26.05.2015 Benchmark ECE-TRANS-WP29-2014-27 and Corr 1
WLTP-11-04e-clean GTR version 26.05.2015

Comments to this clean version

**Proposal for a global technical regulation on
the Worldwide harmonized Light vehicles Test Procedure**

Proposal for a new global technical regulation on the Worldwide harmonized Light vehicles Test Procedure (WLTP)

Figure A5/9
Full Flow Exhaust Dilution System Schematic

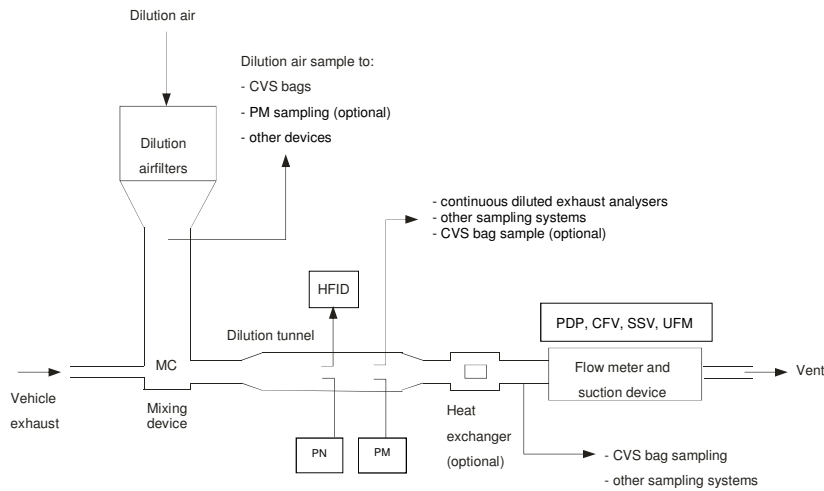
Comment [SMD68]: EXPERT PROPOSAL:
April 2015 drafting meeting, Stockholm

Comment [SMD69]: Completely new diagram. The previous diagram was mistakenly a double of diagram A5/3.

Figure A5/11
Alternative Particulate Sampling Probe Configuration

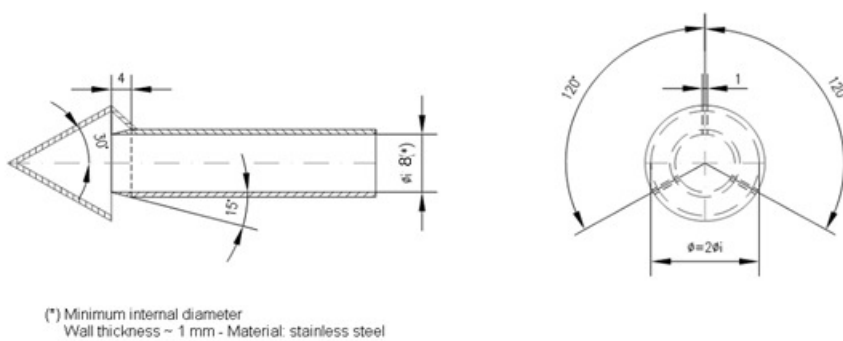
Comment [SMD70]: CONFIRMATION: This diagram moved to here at the March 2015 drafting meeting.

Figure A5/12
Particulate Sampling System

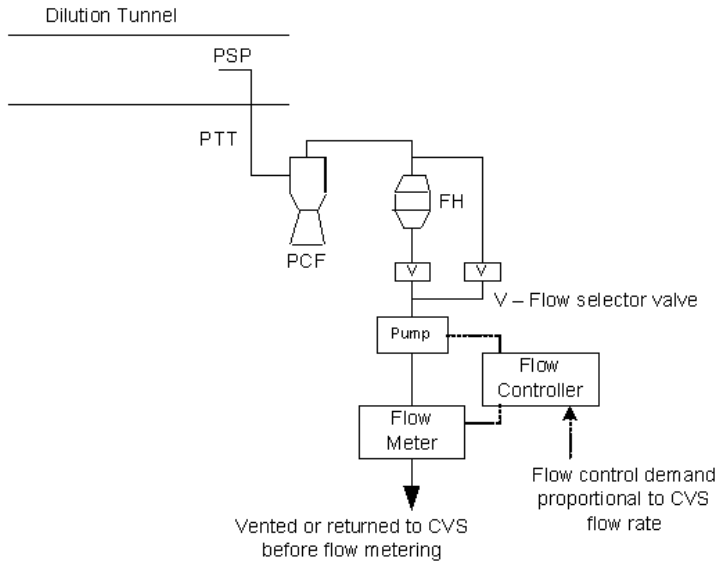
Comment [SMD71]: OPEN POINT: March 2015 drafting meeting: the quality of the diagram will be improved (see L. Hill mail).

- RCB profile OVC-HEV, charge-sustaining test (Figure A8.App1b/1) | |
 Figure A8.App1b/1
OVC-HEV, Charge-sustaining Test

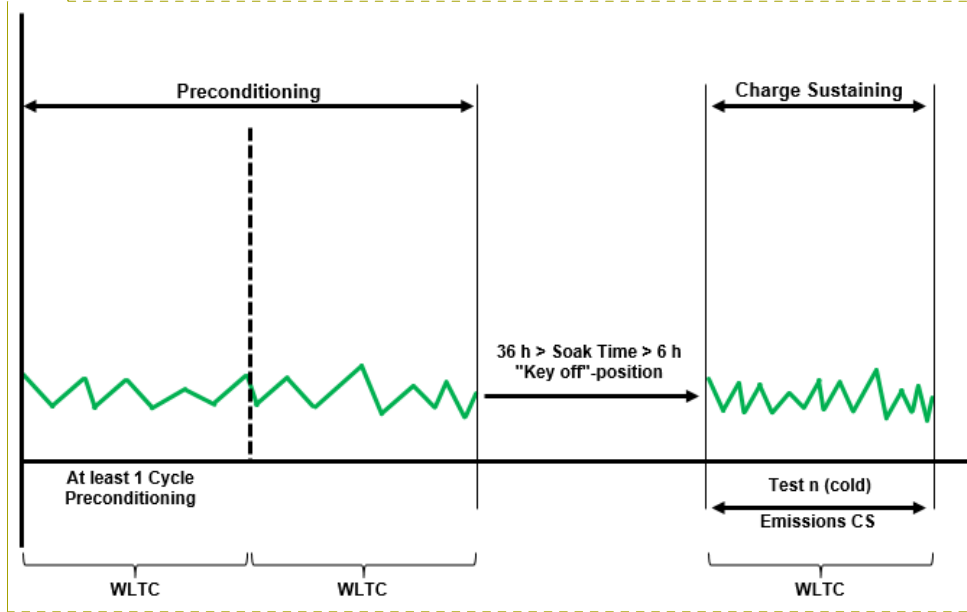
- Comment [SMD116]:** GTR CORRECTION: March 2015 drafting meeting. DC: correct soaking time to be greater than 6 but less than 36 hours. Also, CO2 emissions to be deleted.
- Comment [SMD117]:** GTR CORRECTION: 28.03.2015. Figure deleted and replaced by figure below.
- Comment [SMD118]:** GTR CORRECTION: 28.03.2015. Replaces the above figure (soak time
